Town of Arlington, MA Redevelopment Board

Agenda & Meeting Notice June 2, 2025

2. Public Hearing: Docket #3849, 259 Broadway

To: Arlington Redevelopment Board
From: Claire V. Ricker, AICP Secretary Ex-Officio
Subject: Site Plan Review, 259 Broadway, Docket #3849
Date: May 29, 2025

2 PROPOSED SITE PLAN
SCALE: 1/8" = 1'-0"

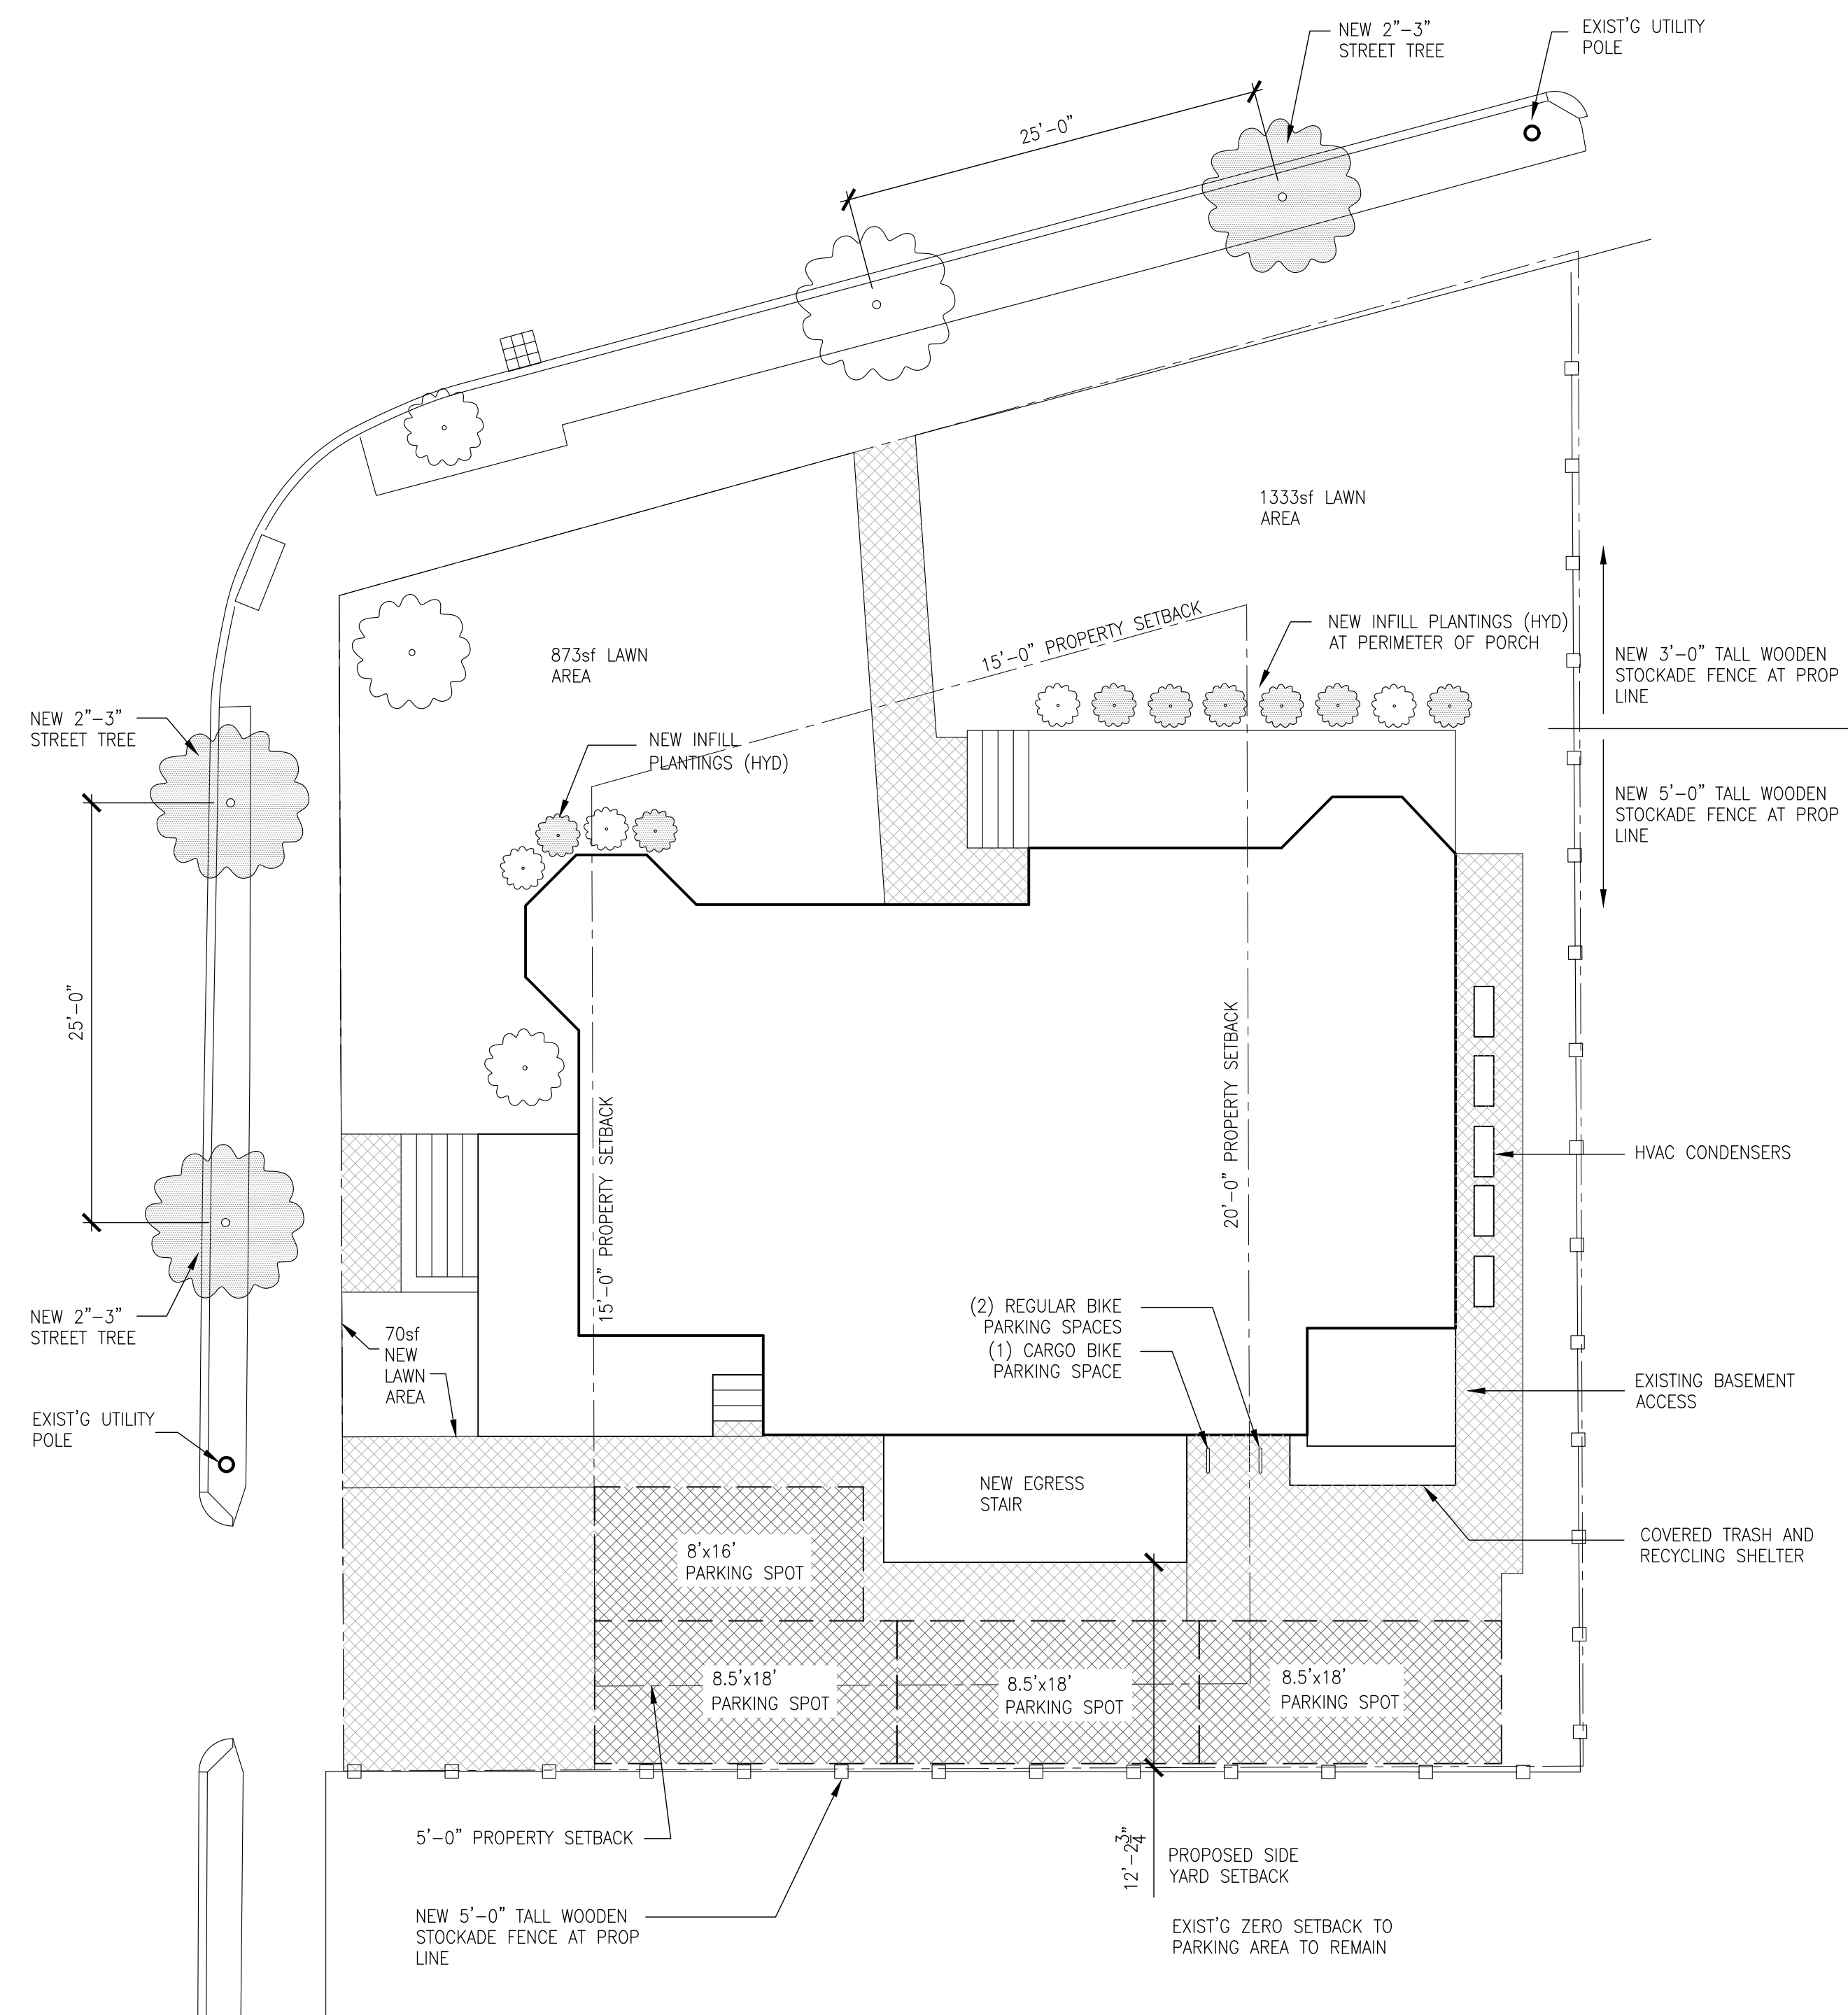
Under the proposal, the number of parking spaces provided will not change. The garage will be demolished with that area continuing to be used for parking. Two EV chargers will be installed, although the locations are not shown on the site plan.

Existing walkways on the site are adequate. Bicycle racks able to accommodate at least one cargo bike will be installed at the rear of the driveway. Long-term bicycle parking will be located down a short flight of stairs in the basement. The applicant should clarify whether a ramp is proposed for the basement stairs and show the location of the proposed racks and 8 long-term spaces on the site plan.
